V1 IS BEING RETURNED PRE-PRB FOR THE FOLLOWING:

Subject: Approval Request: Delphi Muni, Delphi, IN (K1I9)

Delphi Muni, Delphi, IN (K1I9) RNAV (GPS) RWY 18, RNAV (GPS) RWY 36

RNAV (GPS) RWY 18

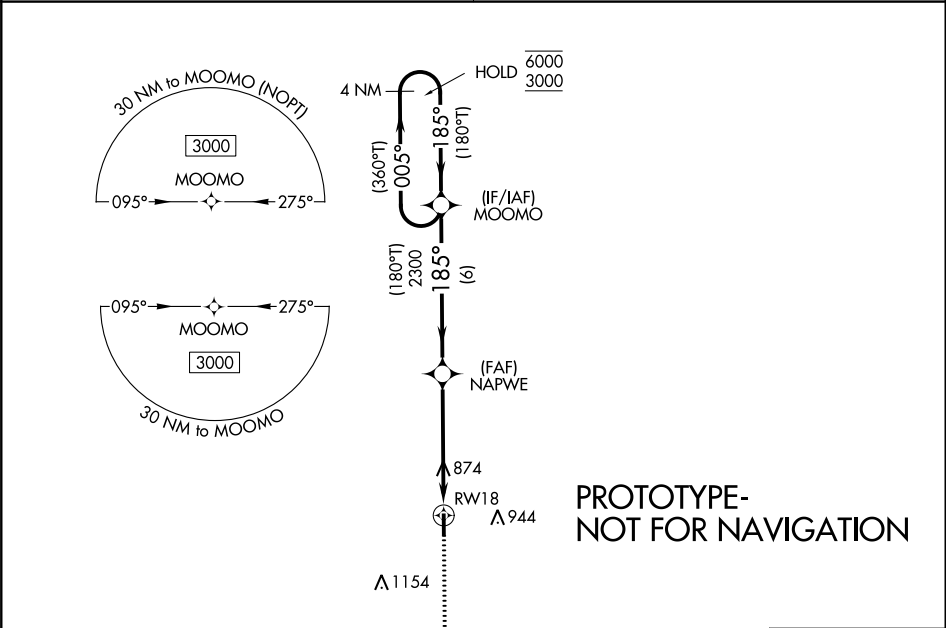
04/19/23: THIS IS AN UPDATED COPY OF THE FORM DEVELOPED ON 09/13/22.
1. REMOVED "CHART NOTE: STRAIGHT-IN RWY 18 AT NIGHT, CIRCLING RWY 18 AT NIGHT, OPERATIONAL VGSI REQUIRED, REMAIN ON OR ABOVE VGSI GLIDEPATH UNTIL THRESHOLD."
2. ADDED "CHART NOTE: PROCEDURE NA AT NIGHT."

RNP APCH - GPS.	MISSED APPROACH: Climb to 3000 direct OCUPA and hold.
⚠ NA Rwy 18 helicopter visibility reduction below 1 SM NA. Use Monticello altimeter setting. Straight-in Rwy 18 NA at night, Circling Rwy 18 NA at night, operational VGSI required, remain on or above VGSI glidepath until threshold.	
MCX AWOS-3P 124.05	CTAF 122.9 0

RNAV (GPS) RWY 18

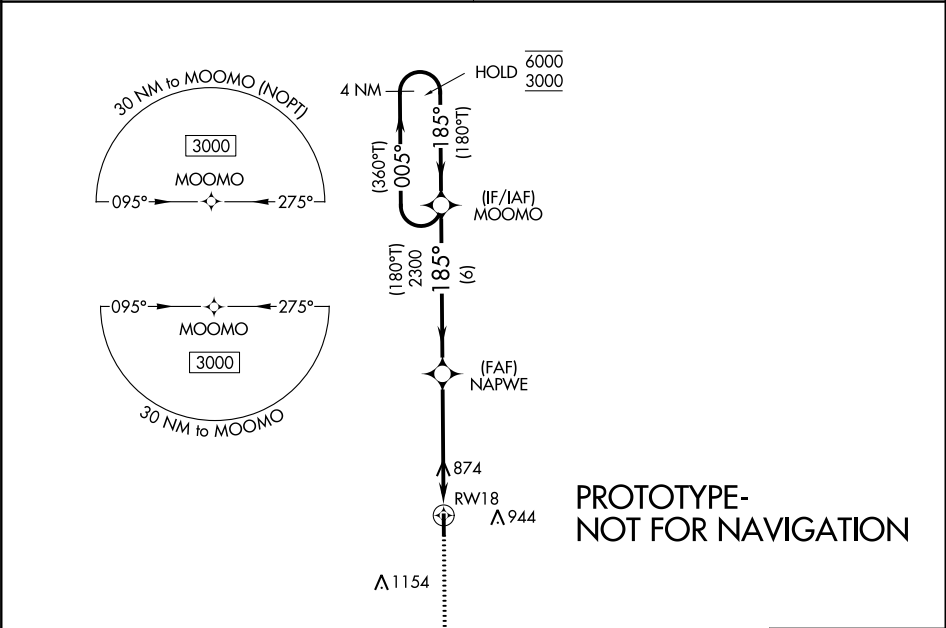
1) THE PACKAGE INCLUDES AN APPROVAL REQUEST TO USE VGSI TO MITIGATE VISUAL SURFACE PENETRATIONS, HOWEVER, AND ADDITIONAL APPROVAL REQUEST IS REQUIRED BECAUSE THE VGSI AND APPROACH SLOPE ARE NOT COINCIDENT.

8260.19I, 8-6-9 M. VGSI AND IAP GLIDEPATH ANGLES/VERTICAL DESCENT ANGLES SHOULD BE COINCIDENTAL (ANGLES WITHIN 0.20 DEGREES AND TCH VALUES WITHIN THREE FEET). SEE ORDER 8260.3, SECTION 2-6, FOR CONDITIONS THAT REQUIRE APPROVAL FROM THE FLIGHT TECHNOLOGIES AND PROCEDURES DIVISION. WHENEVER A PUBLISHED GLIDEPATH/DESCENT ANGLE OR TCH IS NOT COINCIDENT WITH THE VGSI ANGLE FOR A RUNWAY, USE THE APPLICABLE NOTE BELOW.

2) MISSING 20:1 OBSTACLE MITIGATION REQUEST CHECKLIST.

All items corrected.
